SEB Issue List Regarding APR1400 DC FSAR 3.7.1

Issue #1 (AI 3-74.1)

Figure 3-24 Comparison of the Horizontal Target PSD Compatible with APR1400 HRHF Horizontal Response Spectra with the SRP 3.7.1 PSDs for CEUS Rock Sites

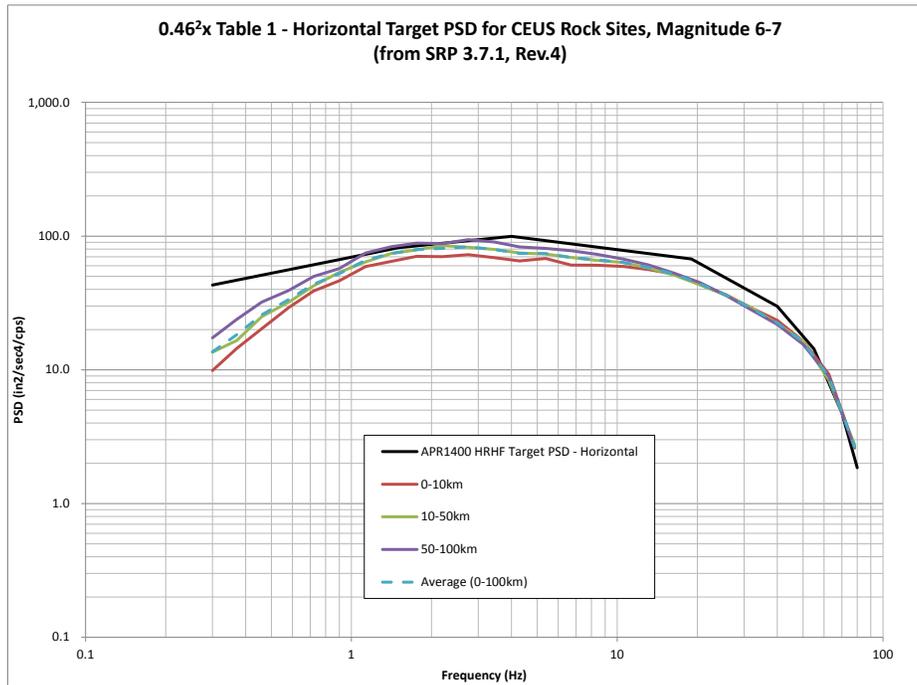
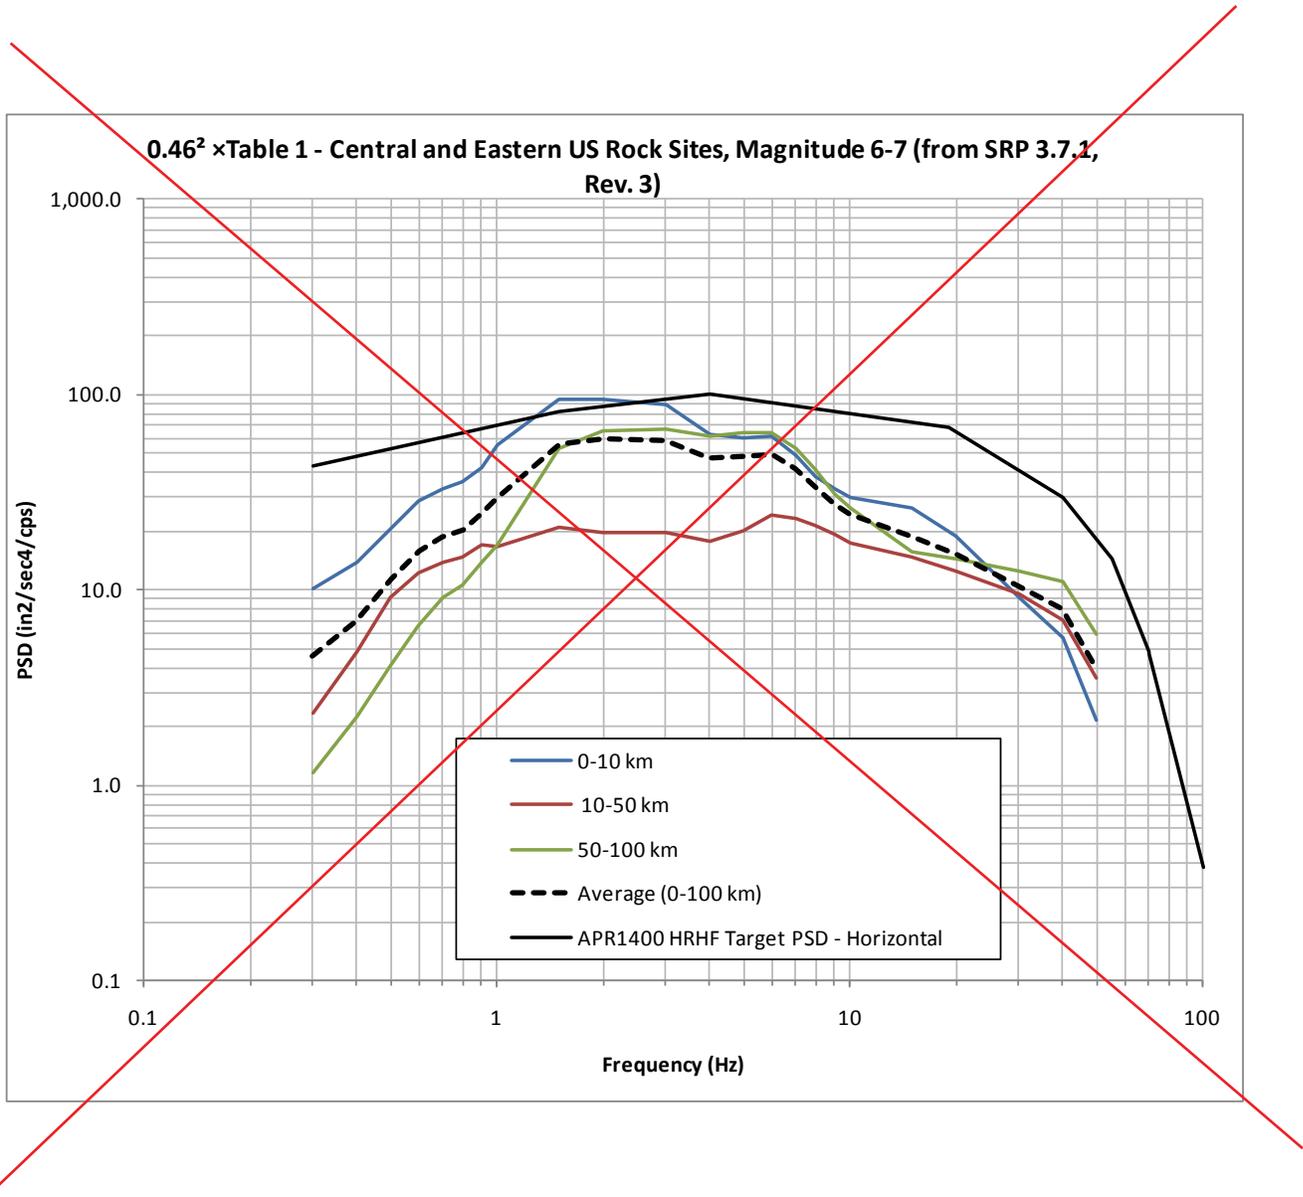
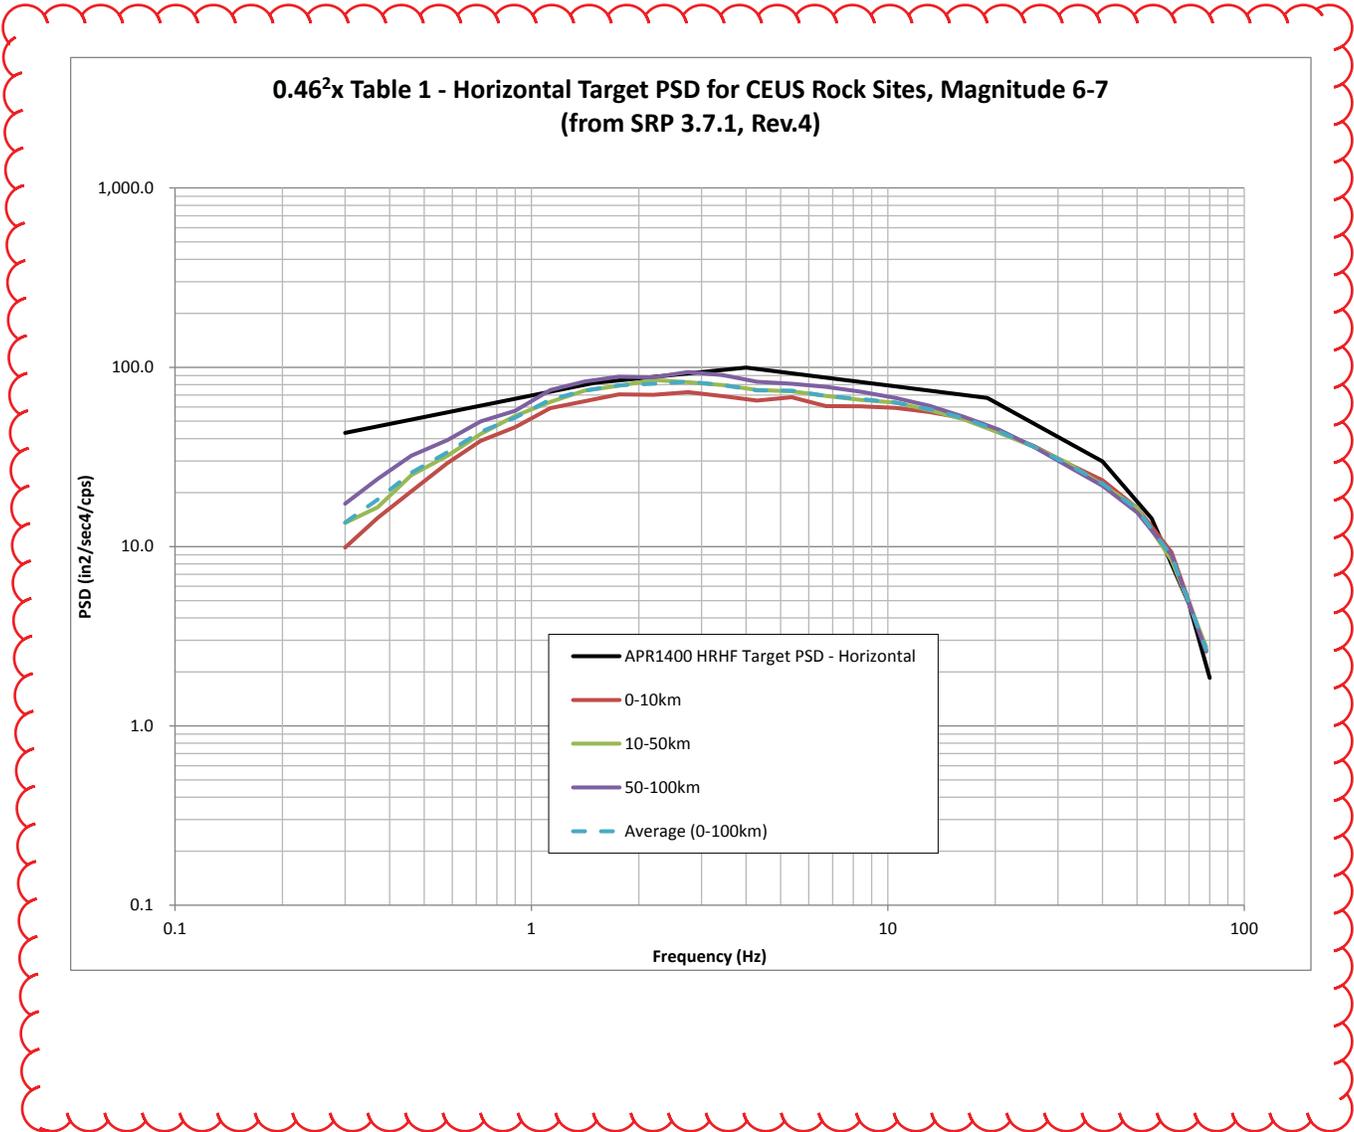
Section 3.5.1 of APR1400-E-S-NR-14004-P, Rev. 1, "Evaluation of Effects of [hard rock high frequency] HRHF Response Spectra on SSCs," compares the APR1400 HRHF horizontal target PSD with the target PSD curves presented in Appendix B of the SRP 3.7.1 Draft Rev. 4, as shown in Figure 3-24 of this report. The PSD tables in Appendix B of the SRP 3.7.1 Draft Rev. 4 were determined to have typos and those target PSDs are generally not compatible with the bin average response spectra. Appendix B of SRP 3.7.1 has been revised in Rev. 4 to address these issues and the guidance in SRP 3.7.1 has been updated. Therefore, comparison to the data in those tables in Appendix B of the SRP 3.7.1 Draft Rev. 4 is not considered to be appropriate and the HRHF report should be revised, as appropriate.

The PSDs presented in Appendix B of SRP 3.7.1 Draft Rev. 4, used for comparison with the APR1400 horizontal target PSD compatible with the HRHF horizontal DRS, will be revised to the PSDs presented in Appendix B of SRP 3.7.1 Rev. 4, as shown in Figure 1. This revised figure of comparison will replace the corresponding figure in Section 3.5.1 of APR1400-E-S-NR-14004-P, Rev. 1.

Technical report, APR1400-E-S-NR-14004-P/NP, Rev. 1, Figure 3-24 will be revised as indicated on the attached markup
